Jicarilla B4 Rio Arriba County, New Mexico Current Well Schematic as of August 1990

Re: Permanent Abandonment
Well: 4 Jicarilla B

CONDITIONS OF APPROVAL

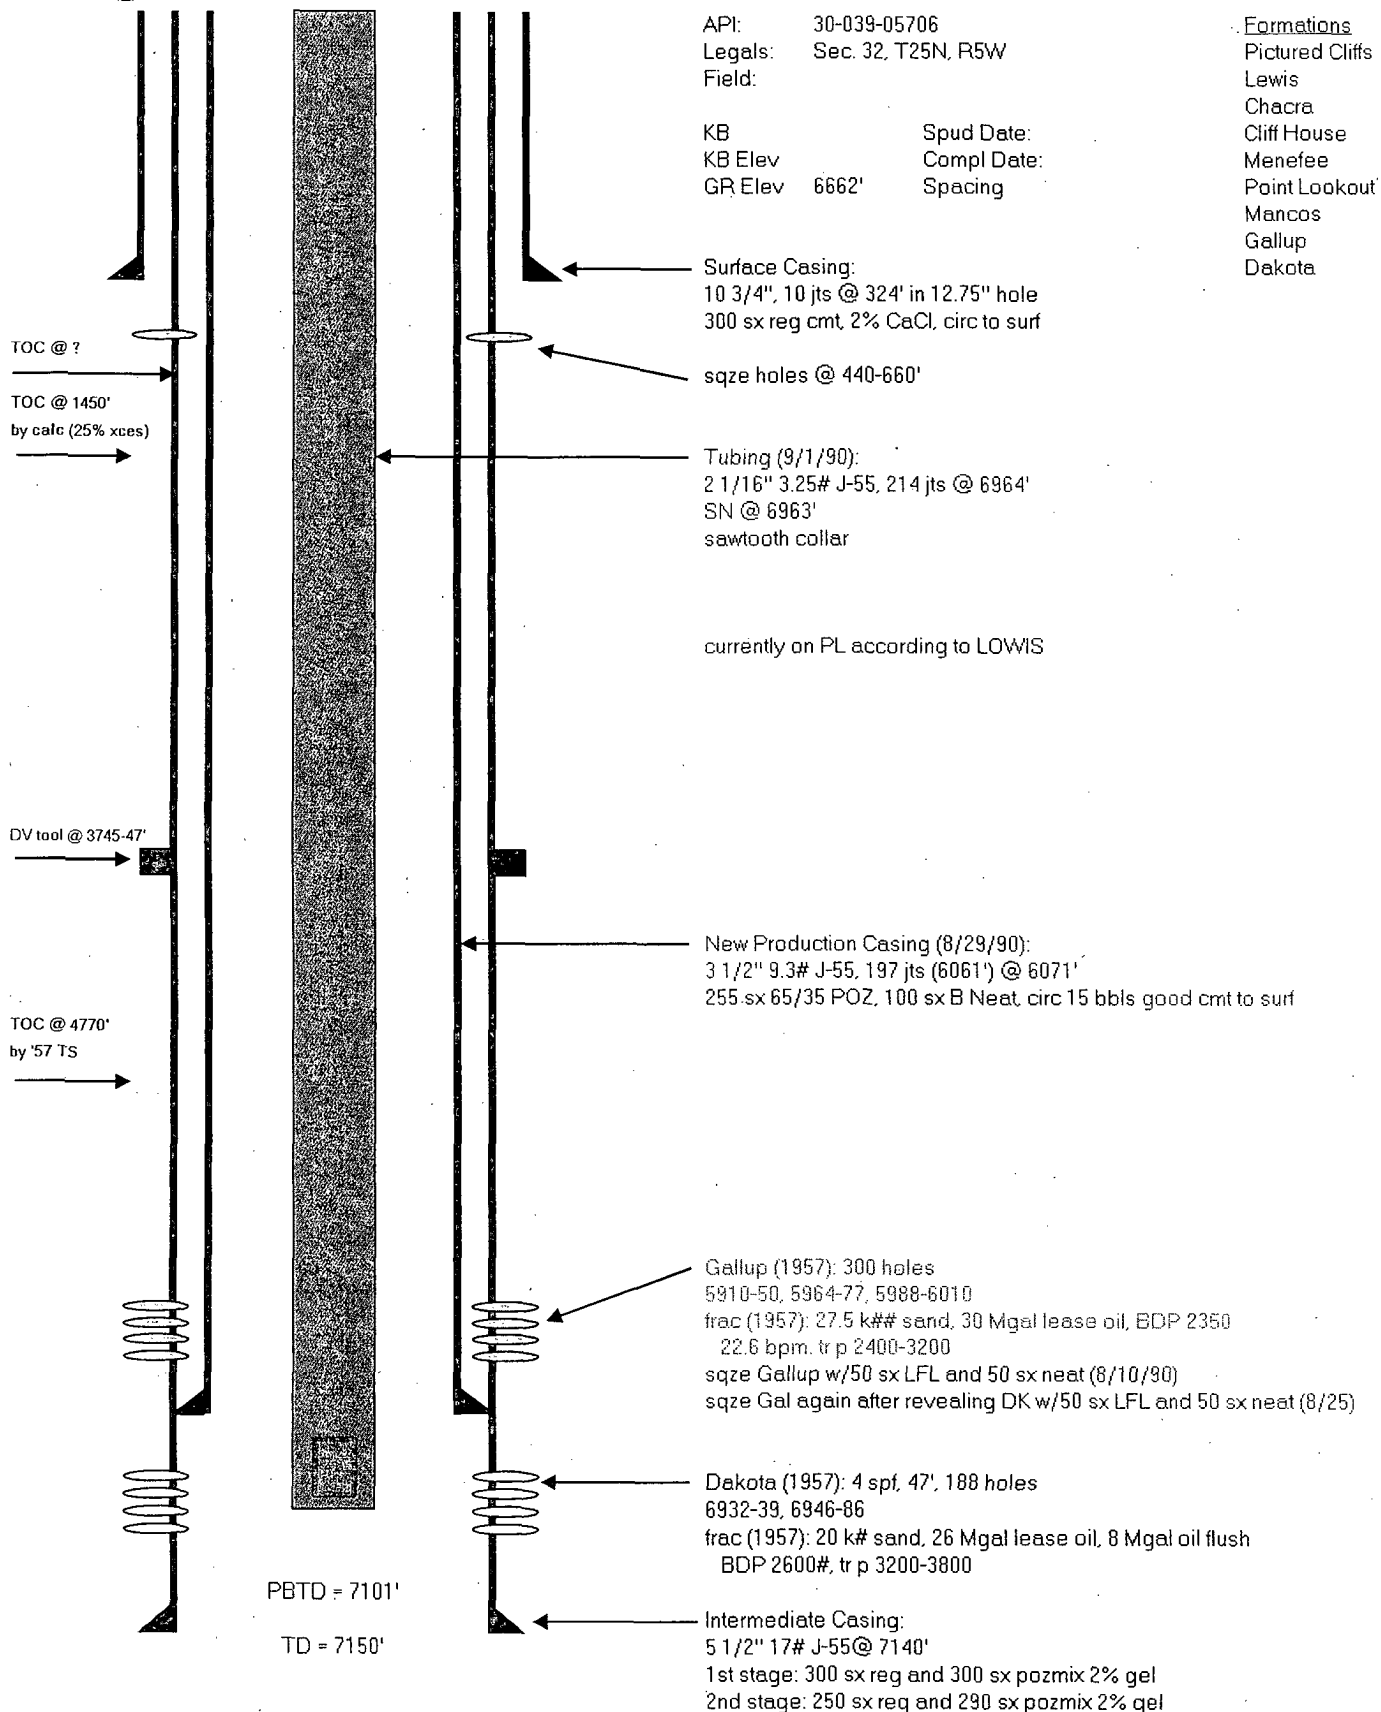
1. Notify BLM 24 hrs prior to MI and RU.
2. RIH squeeze 25sx plug of class "H" cement from 5710'-5910' (perfs). WOC&TAG.
3. Displace hole w/MLF, 9.5# Brine w/25# gel P/BBL.
4. Perf 4 holes at 4220', sqz 160sx cement from 4220'-3645' (Mesaverde/DV tool). WOC&TAG.
5. Spot 30sx cement plug from 2625'-2025' (Pictured Cliffs/Fruitland/Kirtland/Ojo Alamo). 2107' - 2070'
6. Perf 4 holes at 700', sqz 275sx, plug from 700'-surface (Nacimiento/shoe/Fr.Wtr./surface) Verify TOC.
If unable to squeeze, spot cement over Nacimiento and attempt to squeeze shoe plug and same for Fr. Wtr and surface plugs.
Verify any deviation from procedure with BLM inspector and/or BLM engineer.
7. Install dry hole marker.
Additional plugs: 1) 6872'-6772' Dakota
2) 6171'-6071' 3 1/2" casing shoe
Add Churn plug 3350'-3450'

• **REQUIRED PLUGS DISTRICT 1**

1. Plugging operations authorized are subject to the attached "General Requirements for Permanent Abandonment of Wells on Federal and Indian Lease."
2. Farmington Office is to be notified at least 24 hours before the plugging operations commence (505) 599-8907.
3. The following modifications to your plugging program are to be made:
 - a) Place a cement plug from 6872' – 6772' to cover the Dakota top.
 - b) Place a cement plug from 6171' – 6071' to cover the 3 ½" casing shoe.
 - c) Place the Pictured Cliffs/Fruitland/Kirtland/Ojo Alamo plug from 2607' – 2010'.

You are also required to place cement excesses per 4.2 and 4.4 of the attached General Requirements.
